DOCUMENT 00 90 00
ADDENDUM

ADDENDUM NO. [2] **Date: October 29, 2020**

RE: SOUTHWEST WISCONSIN TECHNICAL COLLEGE
BUILDING 400 LECTURE HALL
1800 BRONSON BLVD
FENNIMORE, WI
BID NUMBER: 2021-02

HVAC DUCTWORK REMODEL PLAN

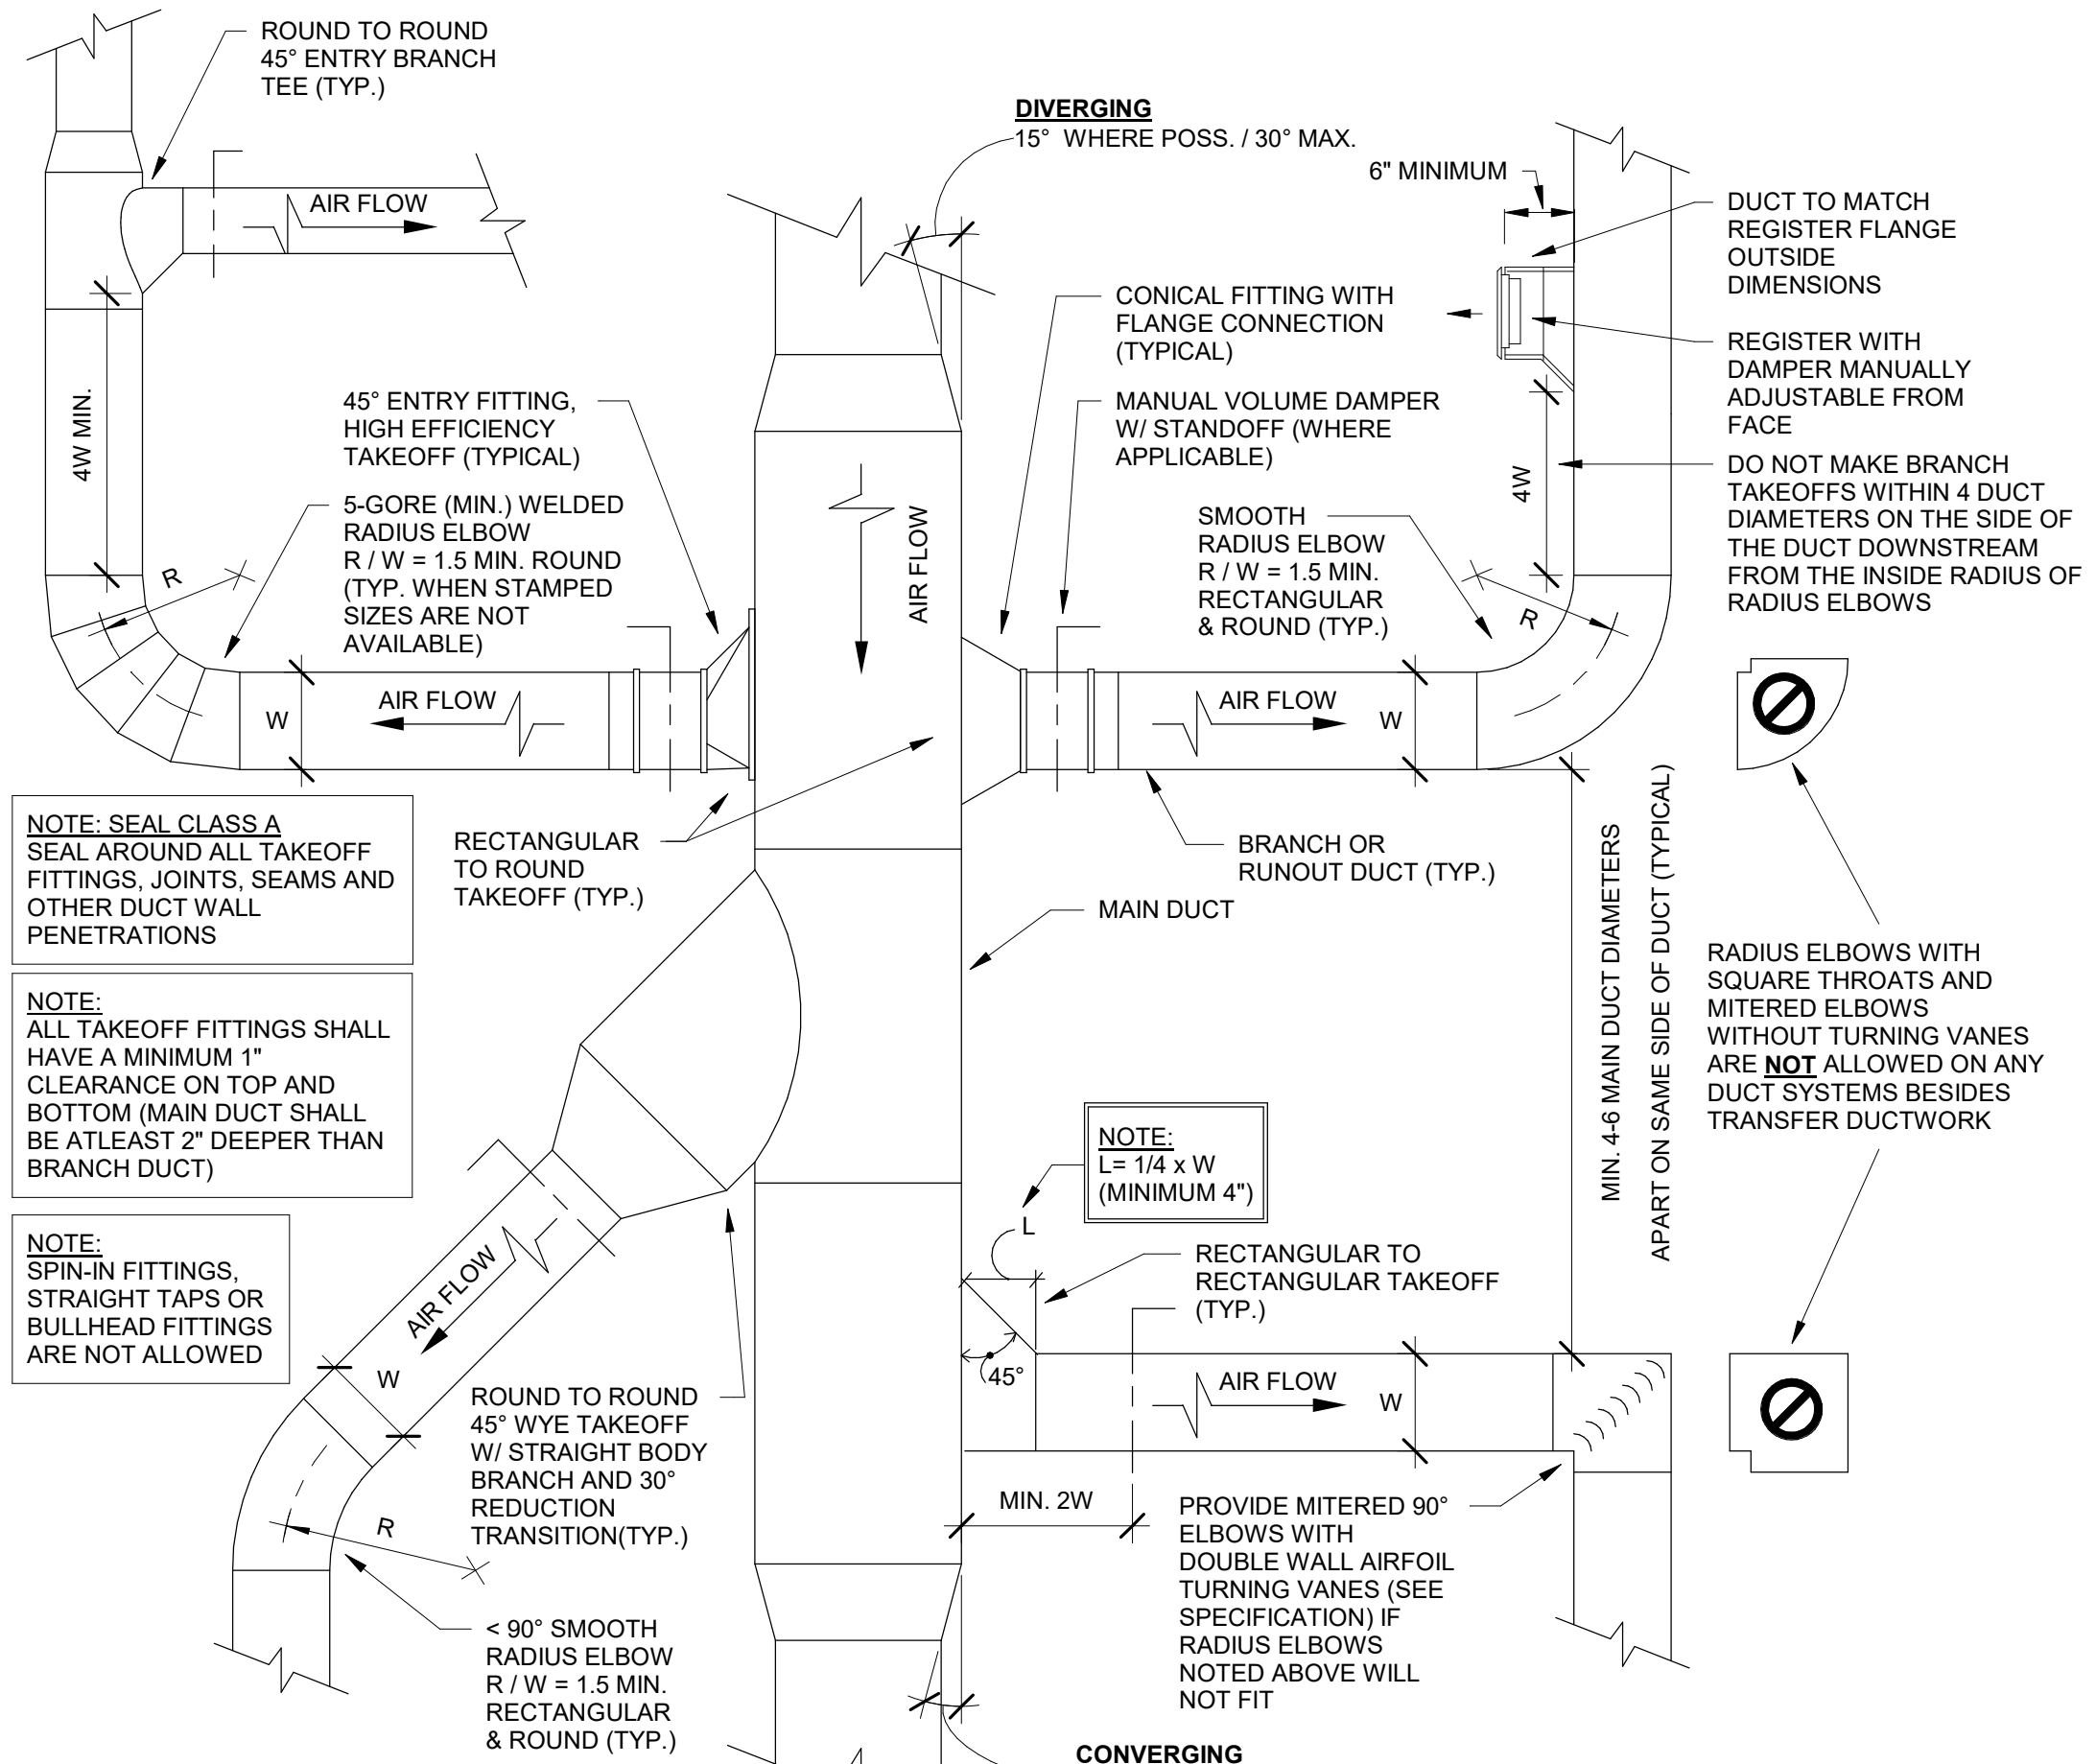
4. Sheet M100 HVAC DUCTWORK REMODEL PLAN 30 x 42 attached hereto
 - a. Revisions clouded on Drawing.
 - b. Moved HVAC Piping Remodel Plan, Mini-Split Unit Detail – Roof Mounted, and Air Cooled Condensing Unit Schedule to sheet M101.

- c. Revised Ductless AC Unit Schedule to show AC-1 model number change from “PKA-A12HA7” to “PKA-A18HA7”.
 - d. Revised unit model of “AC-1” and “CU-1” to depict correct capacity.
